Response to Interactive comment on “In-situ Calibration of Offsetting Magnetometer Feedback Transients on the Cassiope Spacecraft” by David M. Miles et al. by Anonymous Referee #2 on 17 May 2019.

We thank the referee for the constructive comments which we have incorporated into the manuscript. Referee #2 raised several questions and issues which we address below; the referee’s comments are in plain text our responses in *italics* and any content added to or changed in the manuscript are in “*quoted italics*”

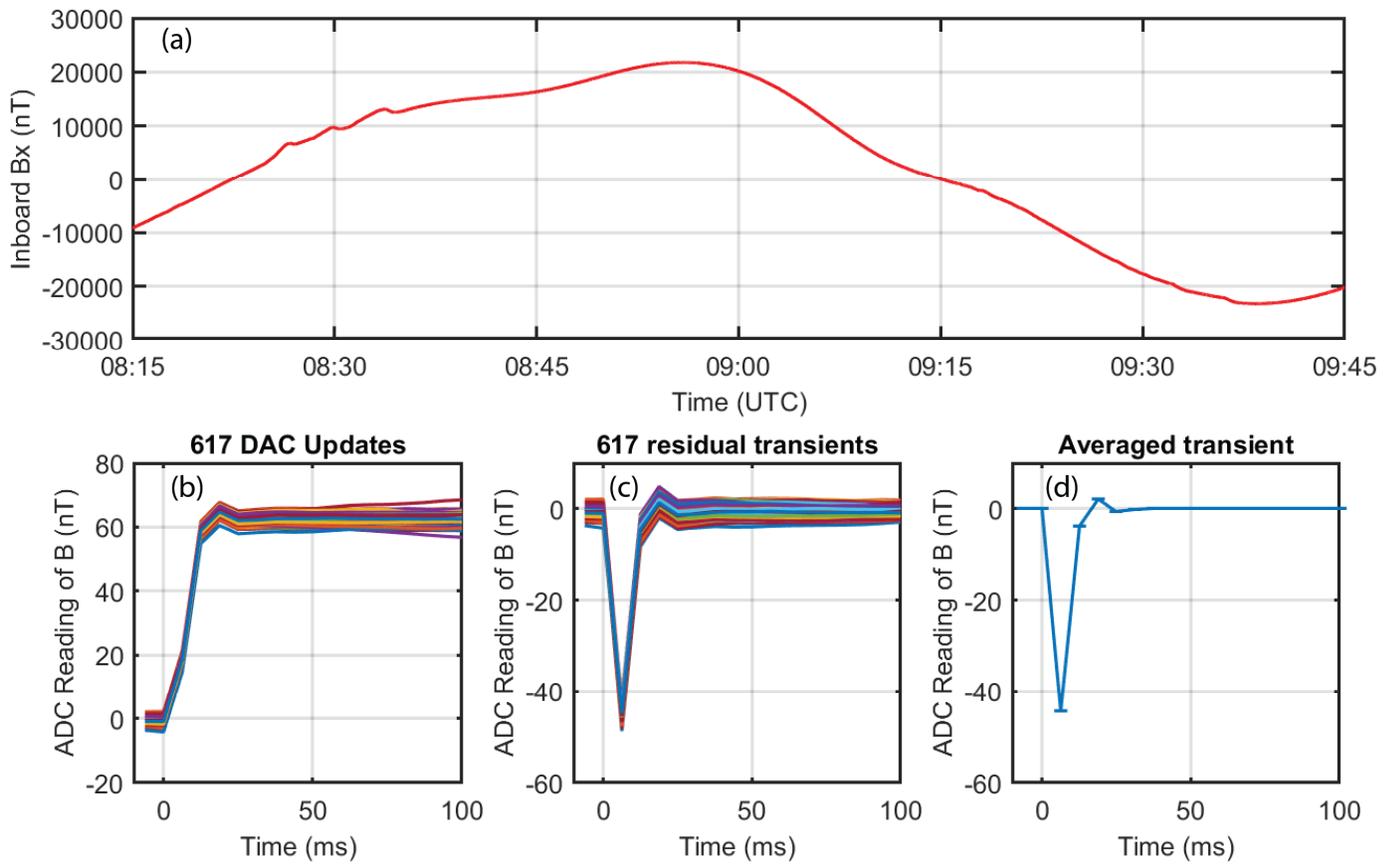
- The major improvement after the fail of one attitude control wheel was possible because of (page 6, line 15): ‘wheel’s spin speed slow enough that their magnetic signatures can be fitted and removed on the timescale of the transients’. This finally crucial, now possible preprocessing step is neither described in a bit more detail nor supported by an illustrative example.

We have added an illustrative example (new Figure 6) and text describing how this fitting was completed.

*Text added: “Figure 1c shows an over plot of 617 ADC sequences from the inboard Bx channel following updates to the magnetic feedback DAC on the same channel. The background trend of the local magnetic field has been removed by subtracting a robust linear regression that excludes the region affected by the transient. Although the scatter is visibly broader than for the no-wheel data shown in **Error! Reference source not found.** the trend of the transient is clear and can be extracted by median filtering as shown in Figure 1d.”*

New Figure 6 added.
